## Product Change Notification

### PCN-PCC-1201-2018

Business Unit	Product Line Code	Type of Change	Action	Date of Issue
PCC - PCB Connectors	AAA	Product Change Notification	Notify Distributors and Field	2/8/2018

#### Description for Product Change Notification

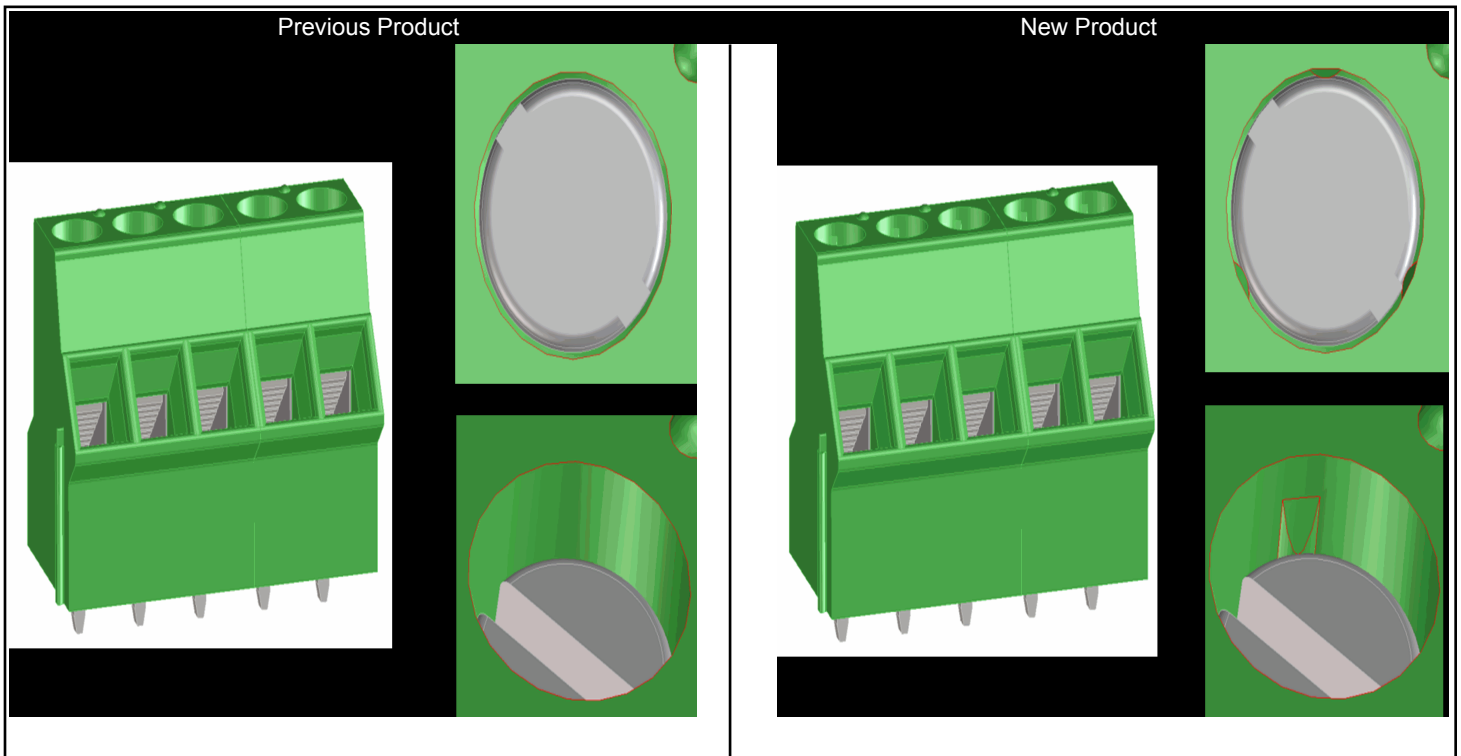
Due to our continuous improvement process the above mentioned articles will be delivered with an additional screw brake. Three plastic fins are inserted in the screw shaft to prevent the closing of the clamping space during transportation. Dimensions and technical data remain the same. During the conversion period both versions will be delivered depending on the inventory.
